Modular Firmware V2.2.62_230204 Release Note

(2023-02-10)

Device Model	DS-KD8003-IME1、DS-KD8003-IME2
Firmware Version	V2.2.62_230204
iVMS-4200 Version	Latest version

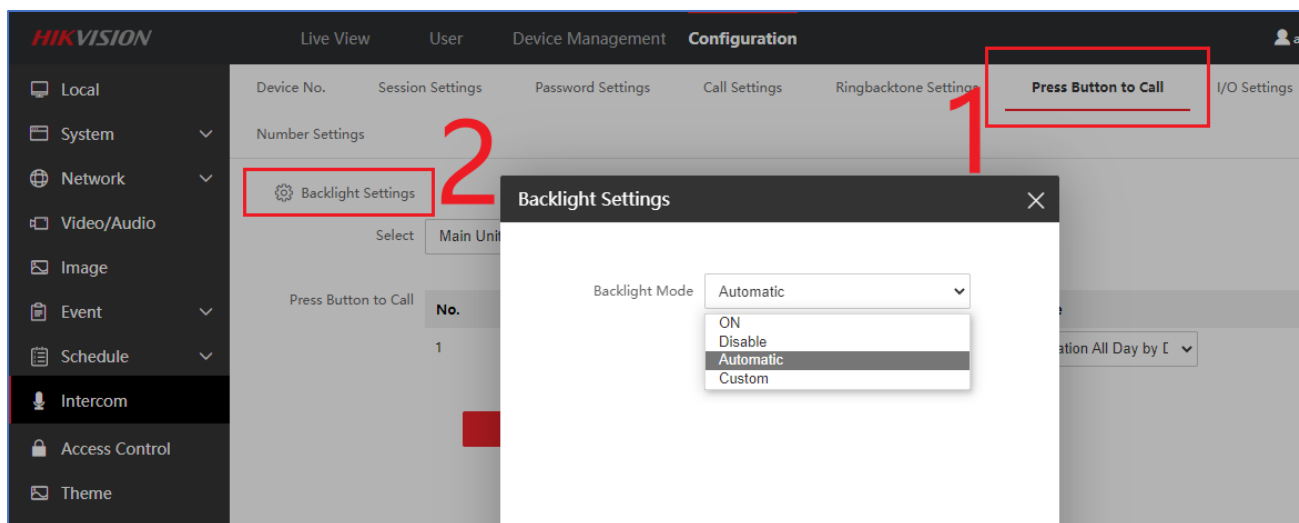
1. Add sub module **backlight** control: 4 modes (close, open, auto and custom), support DS-KD-KK, DS-KD-KP, DS-KD-INFO modules

Close: always OFF

Open: always ON

Auto: ON and OFF according to the ambient light brightness

Custom: ON and OFF according to configured time schedule

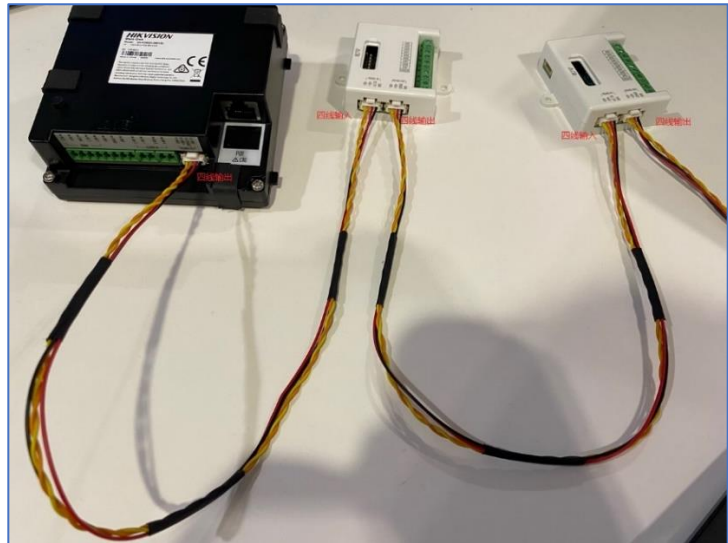
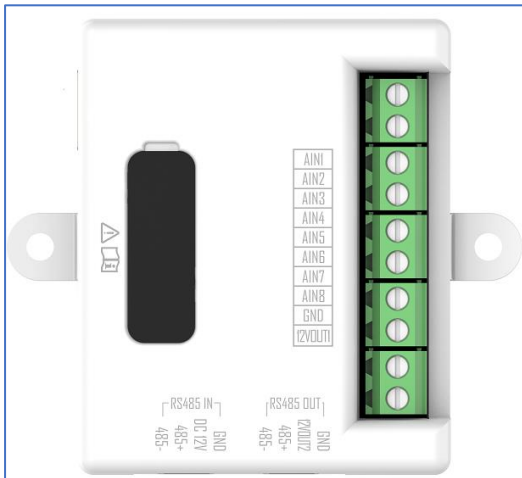
2. Compatible with new button extending sub module DS-KD-AL8, the module is configured and upgrade firmware from main module KD8003 remote configuration, you can link the alarm input No. to indoor station room No., once the input is triggered (short connected), the linked indoor station will be called.

- Maximum support 20 button extending modules cascading
- Each DS-KD-AL8 support 8 alarm input signal, so totally maximum 160 alarm inputs can be connected to one KD8003.
- Each module should have a unique DIP switch address.
- Make sure all modules are connected and each use unique DIP settings before power on the main module KD8003

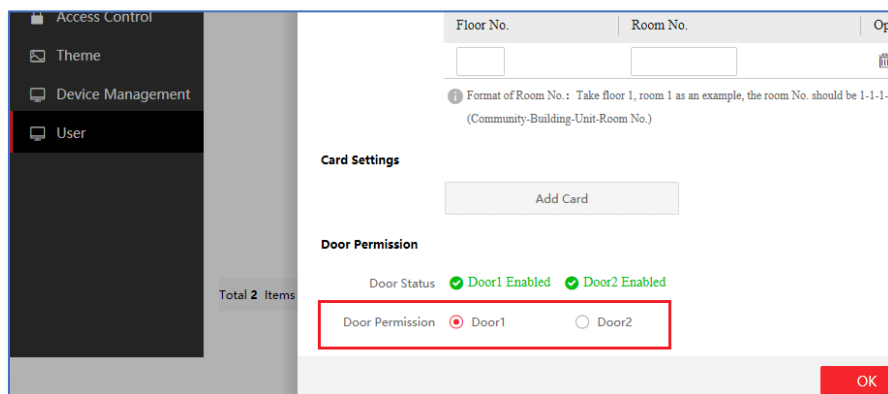
4. Support capture device image through ISAPI protocol.

/ISAPI/Streaming/channels/1/picture?snapshotImageType=JPEG&videoResolutionWidth=1280&videoResolutionHeight=720&imageQuality=better

snapshotImageType: picture format, only support JPEG now

videoResolutionWidth: videoResolutionHeight: picture resolution, if not use this parameter, by default it's 704*576. Supported resolution: 1280*720, 704*576, 704*480, 352*288, 352*240, 176*144, 176*120

imageQuality: support best, better, normal, general

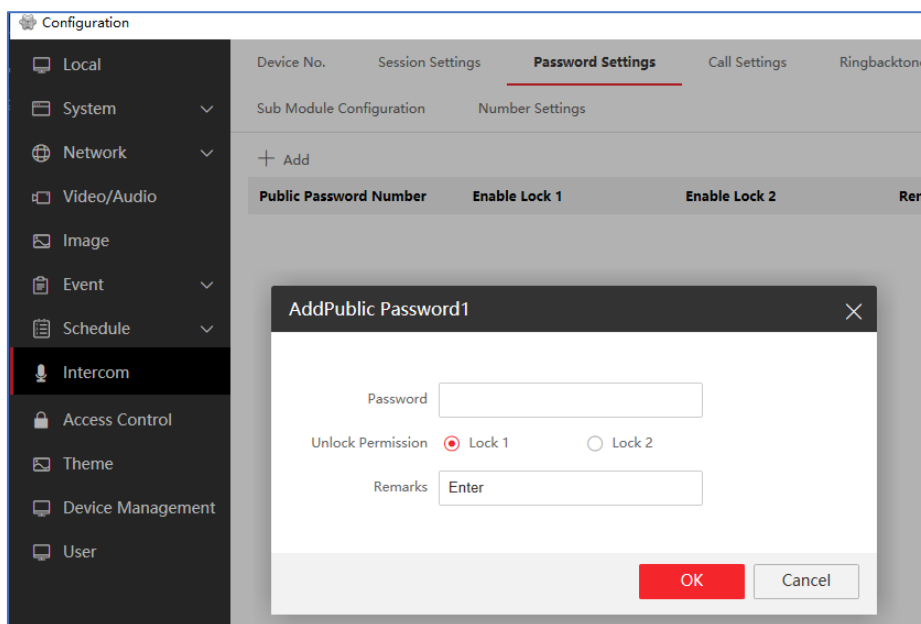
1. Support swipe card to open lock2: when adding new person, you can link to lock 1 or lock 2, and after swipe card, the related lock will be open.

Note: before the lock was linked to card module DIP switch, now we cancelled this logic so that we can open different lock with same card module.

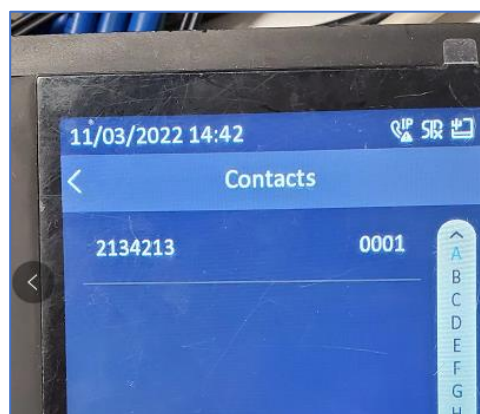
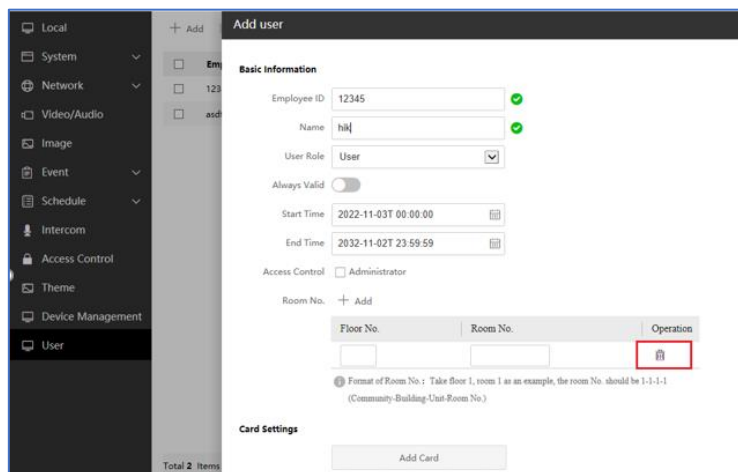
2. Support open door1 and door2 with different public password on same keypad DS-KD-KP or DS-KD-TD module.

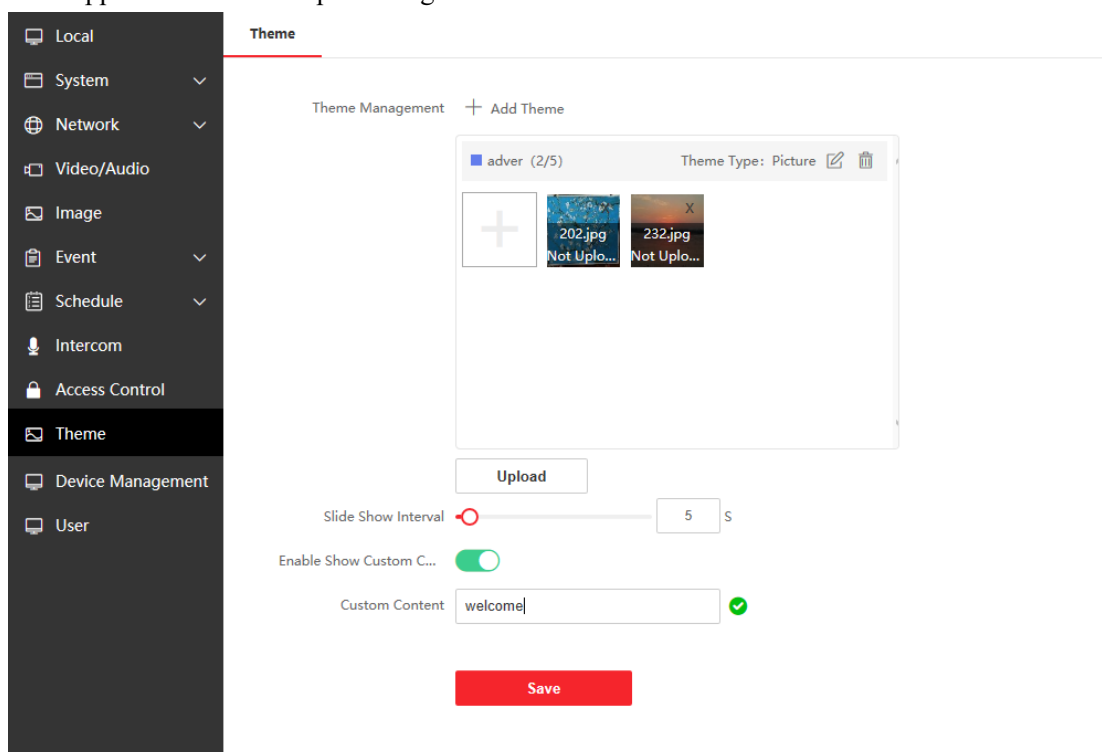
1. Compatible with the Touching Modules:

- DS-KD-TD version: V1.0.1_220607
- DS-KD-TDM version: V1.0.1_220607
- DS-KD-TDE version: V1.0.1_220607

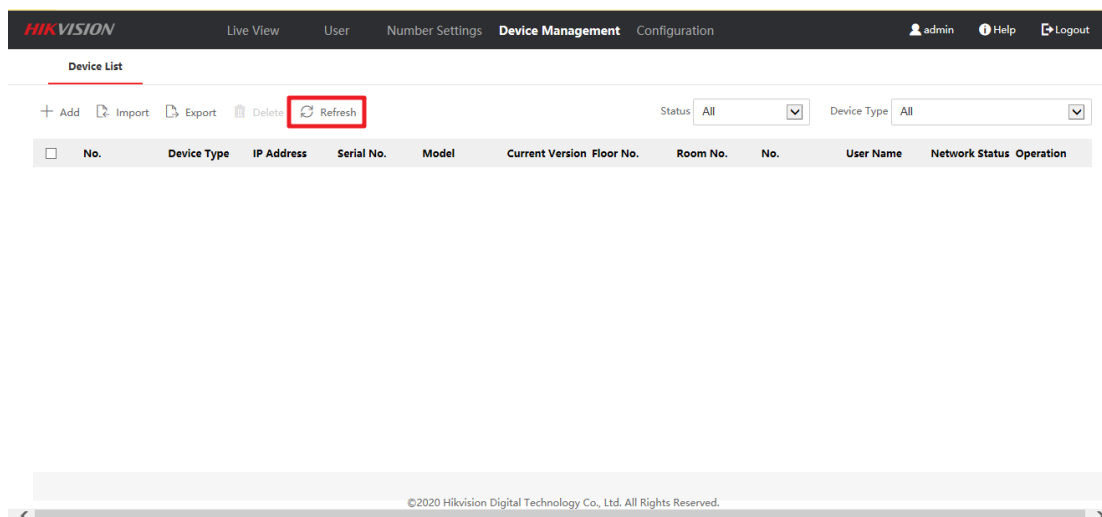
1. New refresh button is used to refresh the status of added devices

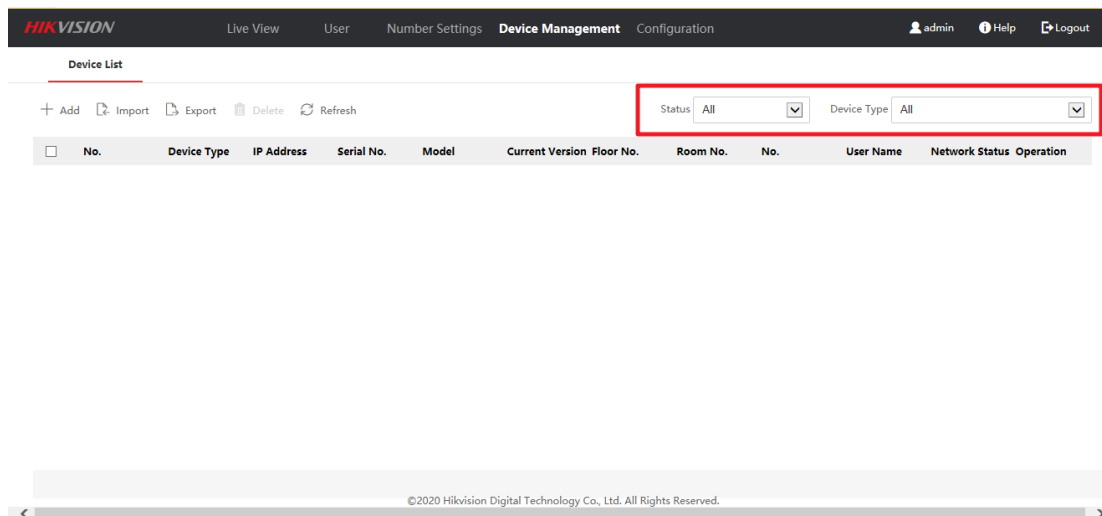
2. Added 'All' option, indoor station and sub-door station will be displayed together.

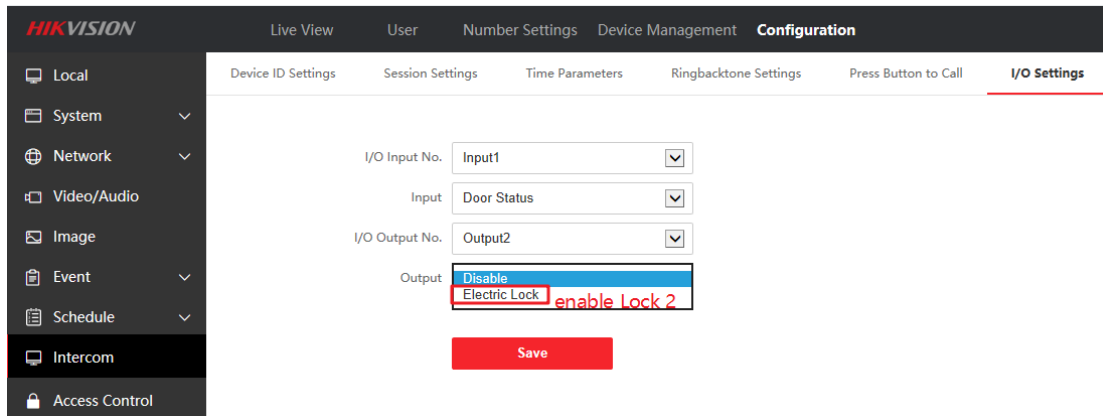
1. Modify the language display of some errors
